**Chemung County Stormwater  
Construction Inspection  
Erosion and Sediment Control**

| <b>Project Name</b> Horseheads Hotel        | <b>Date</b> 8/3/2022       |

PROJECT: Horseheads Hotel  
Village of Horseheads  
Municipal Inspection  
August 3, 2022

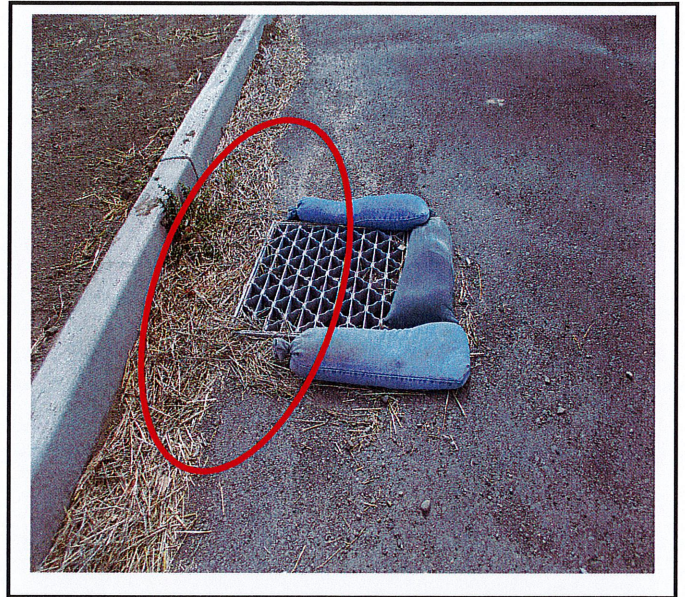
Silt fence is not installed correctly.

Inlet protection placed is not protecting the catch basin. More bags are needed.

Woody vegetation needs to be removed from the forebay.

Some areas have been stabilized with straw mulch.
